PRODUCT IMPROVEMENT BULLETIN

TITLE Carriage Retainer, D3000						PIB NO. DK 3075
PRODUCT TAPE DISK X0 LINE: FORMATTER D		EQUIPMENT CHANGED N/A		MODEL SERIES AFFECTED D3000		EFFECTIVE DATE 3-3-78
CLASS OF BULLETIN: IMPROVEMENT RETROFIT ON FAILURE RETROFIT RECOMMENDED SERVICE INFORMATION ONLY		ECN NO.	10739	:	EFFECTIVITY N/A	
		PARTS KIT NO.	N/A			
		TIME REQ.	N/A

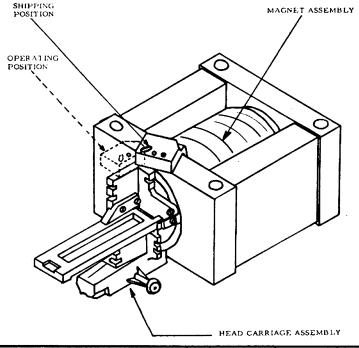
The balance counterweight for the head carriage assembly has been redesigned to serve as a carriage retainer to prevent damage to the head carriage assembly during shipment. This part must be moved from its shipping position to its operating position, before attempting to operate the machine. The illustration shows both positions of the counterweight.

For proper operation of the machine, the weight must be installed on the head carriage, as shown by the dotted outline in the illustration. When the machine is to be transported the weight must be placed back in the shipping position. Both mounting screws should be kept in the carriage assembly to prevent their loss.
